Validation Report

**VALIDATION OF THE CDM-PROJECT:
WASTE HEAT RECOVERY AND UTILIZATION FOR
POWER GENERATION AT LUCKY CEMENT LIMITED,
KARACHI PLANT**

REPORT NO. 1363207

19 February, 2013

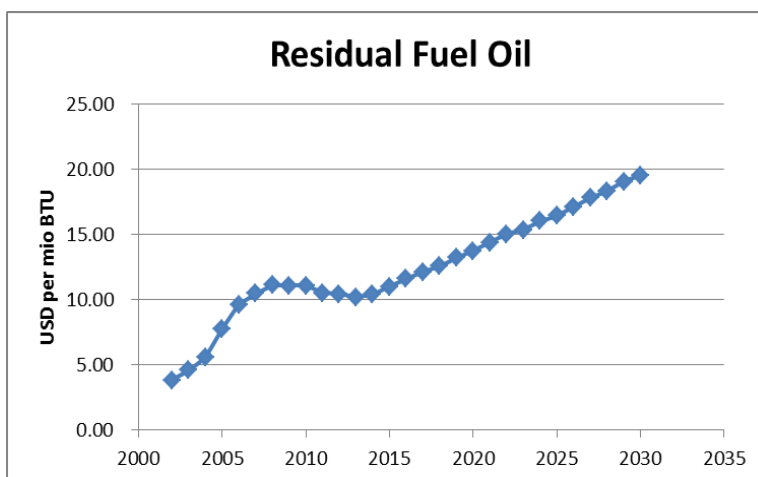
c) The DOE is also requested to clarify whether these yearly inflation rates are applicable to the baseline fuels in Pakistan; . Please refer to paragraph 111 (a) and (b) of VVM version 1.2.

1. Historical International fuel prices along with their projections, as provided at <http://www.eia.gov/oiaf/service/rpt/bmy/index.html>, are given in sheet "AE02006" of the Energy Price Evolution worksheet.

2. An inflationary trend is added to the international fuel price projections (sheet "Basic In- fo_AEO06" of the Energy Price Evolution worksheet) based on the consumer price index values provided by the American Bureau of Labor Statistics. The inflation data is available at http://www.inflationdata.com/Inflation/Inflation_Rate/HistoricalInflation.aspx

3. Determination of correlation between the International Historical Fuel Prices (AEO) and National Historical Fuel Prices (PEYB) and using these correlation factors to forecast the base- line fuel prices in USD.

4. The forecasted baseline fuel prices are converted from USD to PKR using the expected exchange rates. Please refer to sheet "Fut.Price.Evol_HFO", "Fut.Price.Evol_NG" and "Fut.Price.Evol_DIESEL" of the Energy Prices Evolution calculations.

TÜV SÜD confirms that these inflation rates are applicable to the baseline fuels in Pakistan, in the context of the elaboration carried out in the "Energy Prices Evolution.xls", because, as explained above, it is a requirement of the Petroleum Exploration and Production Policy 2007 to refer to international fuel prices for fuel price forecasts. American consumer price index is a suitable proxy for international fuel prices and therefore applicable to Pakistan, as well, once the exchange rate is taken into account.
